Served by WGD: 2/12/2021 2:29:34 PM J.S. Department of the Interior BUREAU OF LAND MANAGEMENT		Sundry Print Repo 07/12/2021
Well Name: MUY WAYNO 18 FEDERAL	Well Location: T25S / R30E / SEC 18 / NENW / 32.129178 / -103.923072	County or Parish/State: EDDY / NM
Well Number: 124H	Type of Well: CONVENTIONAL GAS WELL	Allottee or Tribe Name:
Lease Number: NMLC0065705B, NMLC065705B	Unit or CA Name:	Unit or CA Number:
US Well Number: 3001544843	Well Status: Approved Application for Permit to Drill	Operator: XTO ENERGY INCORPORATED

Type of Submission: Notice of Intent

Procedure Description: **Spacing, Casing/Cement, Drilling Variance Changes XTO Permian Operating, LLC requests permission to make the following changes to the original APD: No Additional Surface Disturbance Change BHL fr/200'FNL & 2310'FWL to 200'FNL & 1590'FWL Casing/Cement design per the attached drilling program. XTO also requests the following variances: Approval to utilize a spudder rig to pre-set surface casing per the attached description of operations. Batch drill this well if necessary. In doing so, XTO will set each casing string and ensure that the well is cemented properly and the well is static. With floats holdi

Wellhead diagram during skidding operations

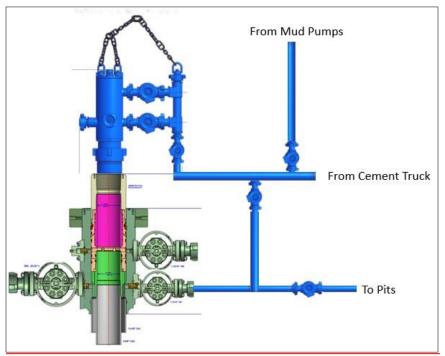
- 6. Skid rig to next well on pad.
- 7. Confirm well is static before removing cap flange, flange will not be removed and offline cementing operations will not commence until well is under control. If well is not static, casing outlet valves will provide access to both the casing ID and annulus. Rig or third party pump truck will kill well prior to cementing or nippling up for further remediation.

- a. Well Control Plan
 - i. The Drillers Method will be the primary well control method to regain control of the wellbore prior to cementing, if wellbore conditions do not permit the drillers method other methods of well control may be used

Wellhead diagram during skidding operations

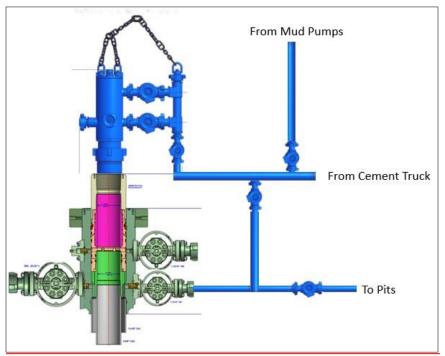
- 6. Skid rig to next well on pad.
- 7. Confirm well is static before removing cap flange, flange will not be removed and offline cementing operations will not commence until well is under control. If well is not static, casing outlet valves will provide access to both the casing ID and annulus. Rig or third party pump truck will kill well prior to cementing or nippling up for further remediation.

- a. Well Control Plan
 - i. The Drillers Method will be the primary well control method to regain control of the wellbore prior to cementing, if wellbore conditions do not permit the drillers method other methods of well control may be used

Note: Picture below highlights BOP components that will be tested during batch operations

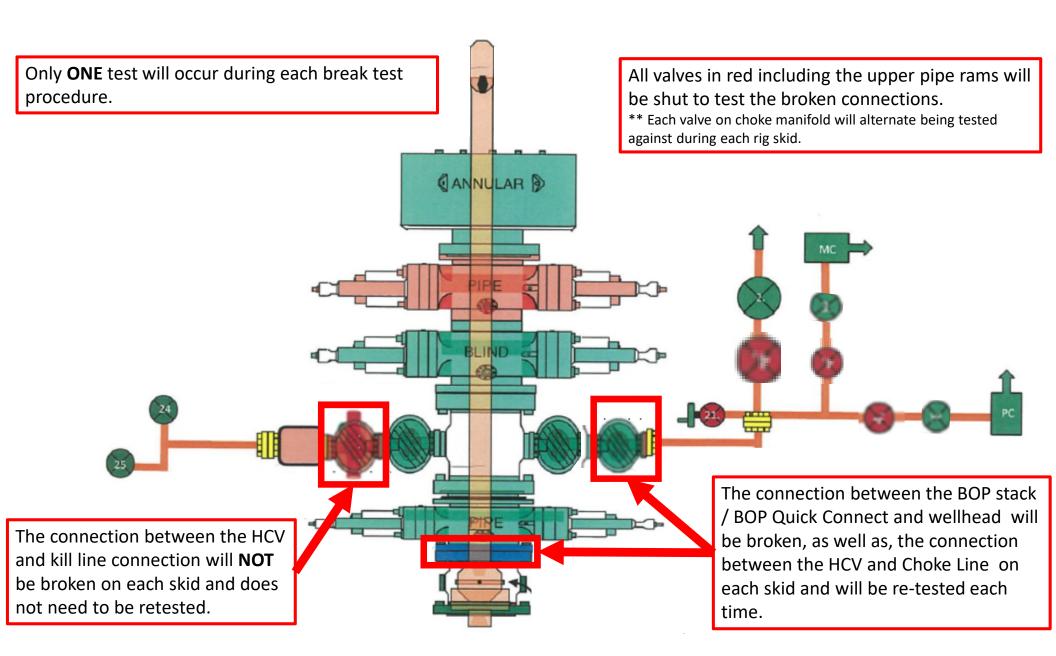
A variance is requested to **ONLY** test broken pressure seals on the BOP equipment when moving from wellhead to wellhead which is in compliance with API Standard 53. API Standard 53 states, that for pad drilling operation, moving from one wellhead to another within 21 days, pressure testing is required for pressure-containing and pressure-controlling connections when the integrity of a pressure seal is broken.

The BOP will be secured by a hydraulic carrier or cradle. The BLM will be contacted if a Well Control event occurs prior to the commencement of a BOPE Break Testing operation.

Based on discussions with the BLM on February 27th 2020 and the supporting documentation submitted to the BLM, we will request permission to ONLY retest broken pressure seals if the following conditions are met:

1. After a full BOP test is conducted on the first well on the pad.

4. Full BOP test will be required prior to drilling the production hole.
